Re: Comments on NIPSCO's 2018 Integrated Resource Plan

**Report on NIPSCO 2018 IRP
Submitted to the IURC on March 1, 2019**

**on behalf of CAC, Earthjustice, IndianaDG,
Sierra Club, and Valley Watch**

Figure 3. NIPSCO 2018 IRP Figure 2-1: Overall Integrated Resource Planning Approach

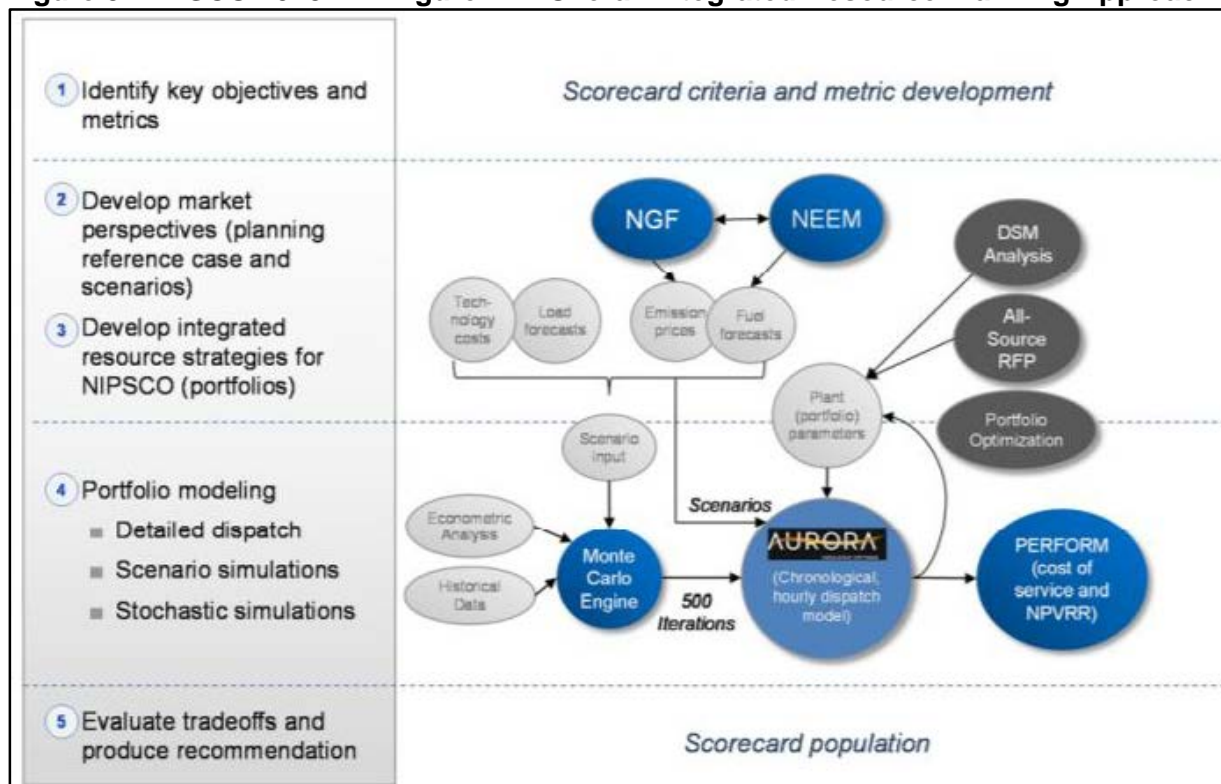
Section 2.3 in NIPSCO’s IRP presents its resource planning approach (see Figure 3), including a description of the model structure and applicability. IRP Section 2.3 shows the steps NIPSCO undertook for their resource planning approach. The Company first conducted a retirement analysis and then developed its replacement portfolios. NIPSCO used Aurora’s portfolio optimization tool to develop least-cost portfolios to replace retiring units in its modeling of retirement portfolios. After constructing portfolios, CRA would use Aurora to simulate hourly dispatch of the portfolios within the MISO market. The output from the Aurora dispatch is then used as an input to the PERFORM model in order to help construct the stream of annual revenue requirements of each portfolio.

Figure 4. NIPSCO 2018 IRP Figure 9-17: 2023 Incremental Replacement Resources by Portfolio (UCAP MW)

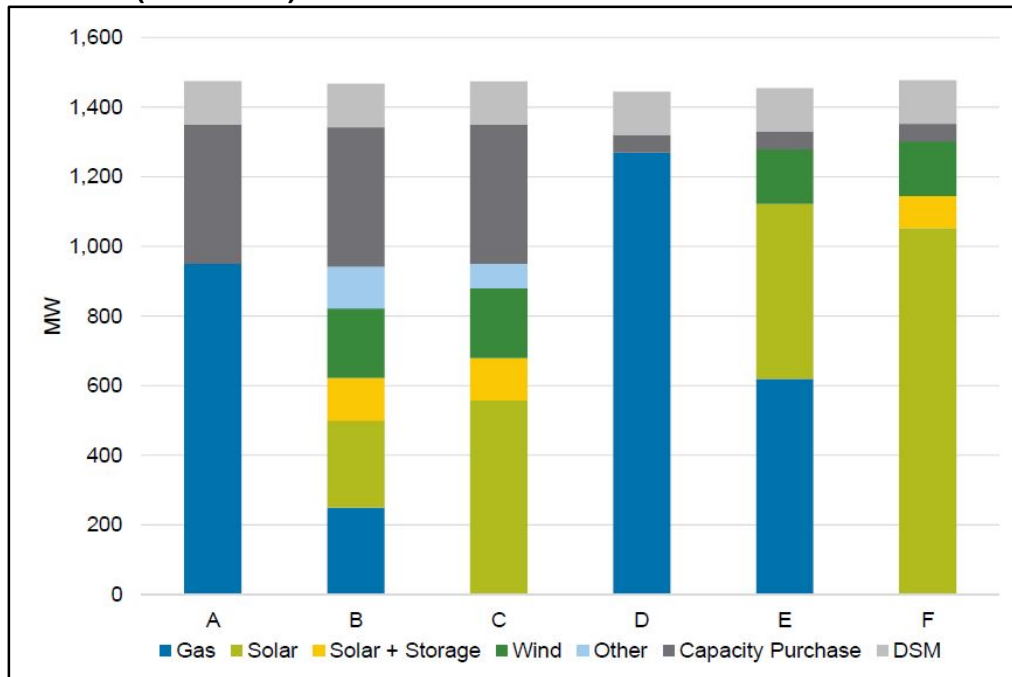
Yes. Section 9.2 in NIPSCO’s IRP discusses its replacement analysis, and each portfolio under the analysis contains both supply-side and demand-side resources (see Figure 4 and Figure 5) and were analyzed according to six metrics that were defined prior to the commencement of analysis: cost to consumer, cost certainty, cost risk, fuel security, environmental, and local economy (see Figure 6).

Mostly. Section 9.2.3 in NIPSCO’s IRP presents the development of specific replacement portfolios, while IRP Section 9.3.2 presents its preferred plan. All replacement portfolios included demand-side resources (see Figure 4 and Figure 5 above), as did NIPSCO’s preferred portfolio (see Figure 10 above). All replacement portfolios were analyzed according to six metrics that were defined prior to the commencement of analysis: cost to consumer, cost certainty, cost risk, fuel security, environmental, and local economy (see Figure 6 above).

Figure 8. NIPSCO peak load

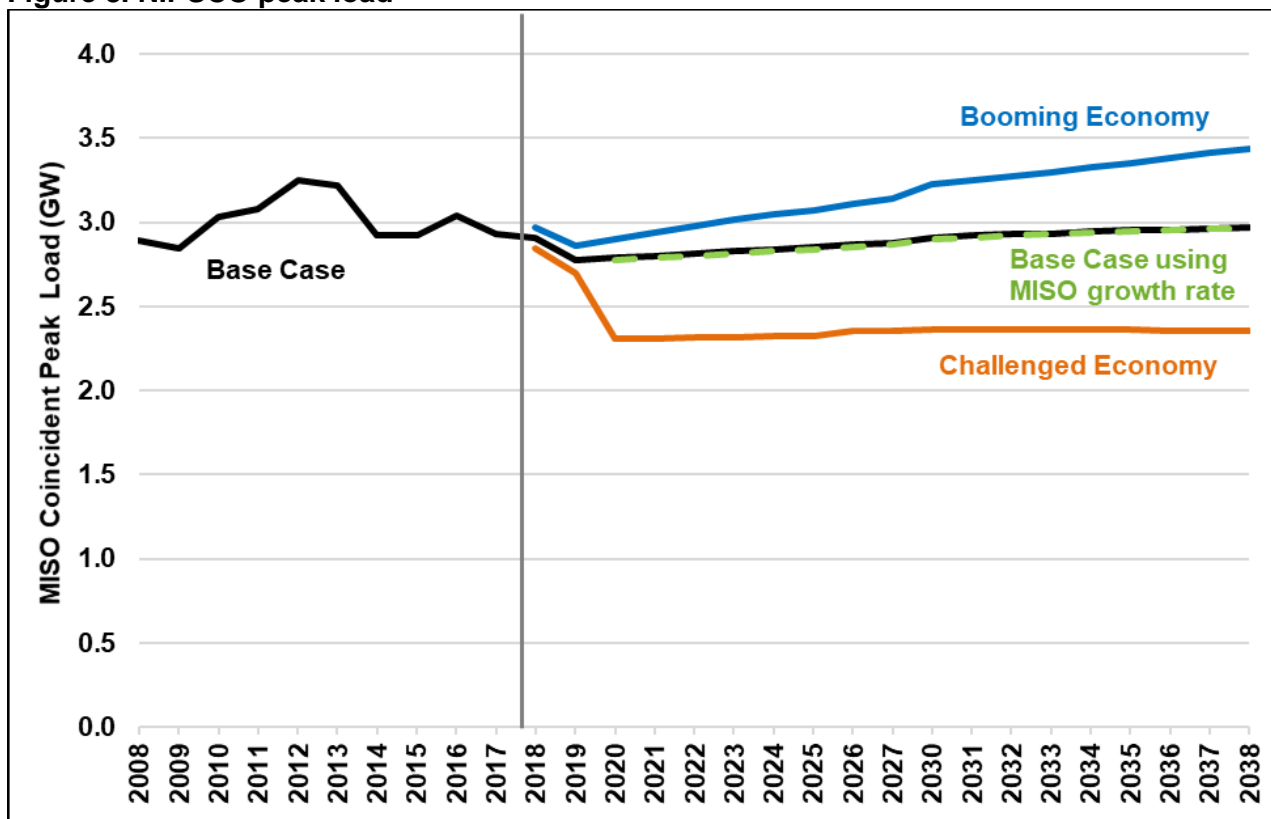
Yes. NIPSCO’s IRP includes Baseline, Booming and Challenged forecasts of peak load and energy demand that are comparable to MISO’s forecasts (see Table 12, Figure 8, and Figure 9). NIPSCO models a loss of industrial load in its Challenged scenario, but not in its Baseline scenario. While, ultimately, these alternative scenarios do not appear to have had an important effect on the choice of the preferred portfolio, more complete information should be included in the IRP regarding the assumptions behind these choices.

Figure 10. NIPSCO 2018 IRP Figure 9-29: Preferred Portfolio Energy Mix

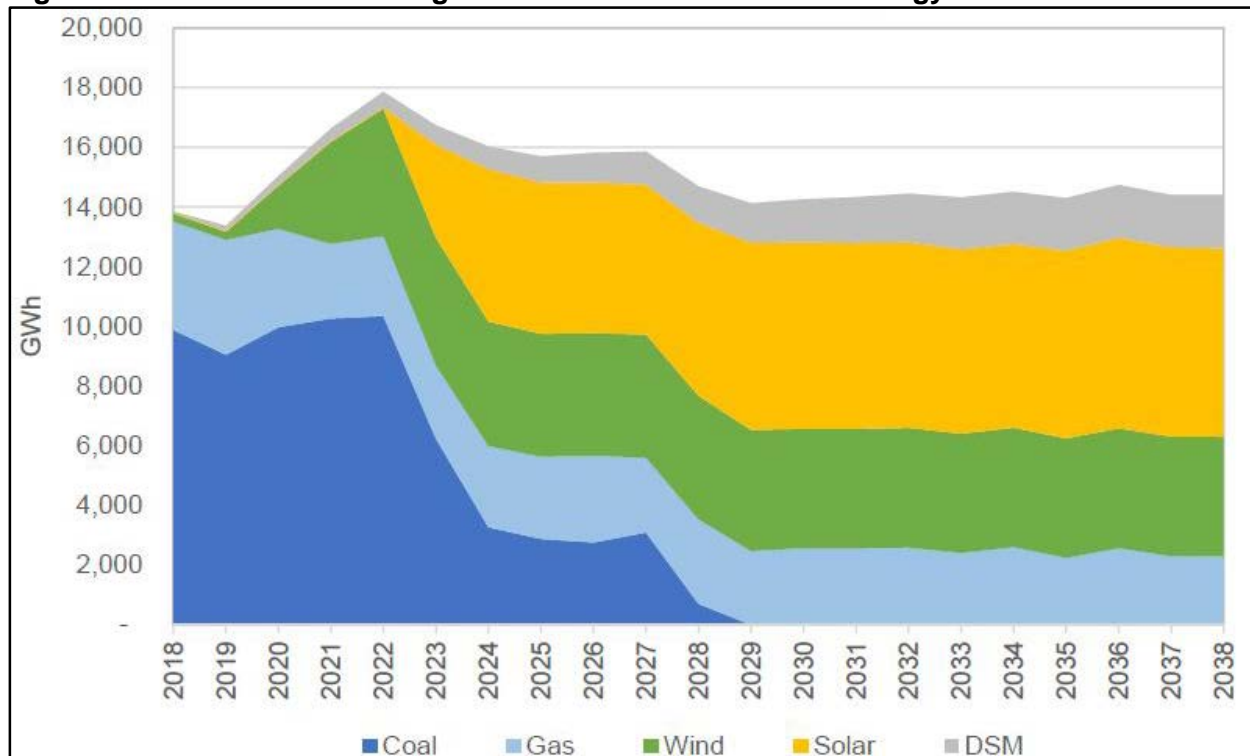
Mostly. Section 9.3 in NIPSCO's IRP provides a description of their Preferred Replacement Portfolio. However, while NIPSCO's IRP does include a figure showing the change in their energy mix over time (see Figure 10), it does not include or present details about specific capacity additions and retirements by year and size. This additional information is necessary and would aid stakeholders and NIPSCO in future planning and action items.
